INDESIT company

Model type:
BAAN12FR

Commercial code:
F044462

General notes

N1030093fig1

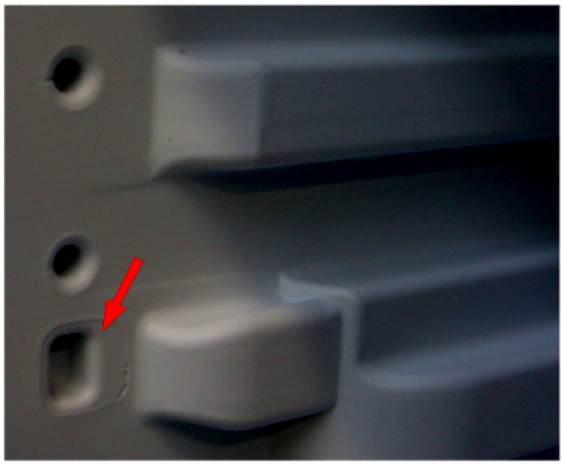
n1030093: New fixing of evaporator on static fridge-freezers (05 range) 60 cm,Melano

From August 05 (serial no. 50802.0001) the freezer evaporator is secured to the cabinet by a plastic profile.
The cabinet walls have been modified to create locations to house the profile, which is installed on the front of each evaporator plate (see photo N1030093fig1- fig2 - fig3)
The profile cannot be fitted on premodification appliances, so technical personnel must continue to fit the rh and lh supports on these models (see photo N1030093fig4)

New parts
C00141135 = WHITE PROFILE L=443.5 MM

Parts replaced
C00075596 = EVAPORATOR RH SUPPORT
C00075597 = EVAPORATOR LH SUPPORT
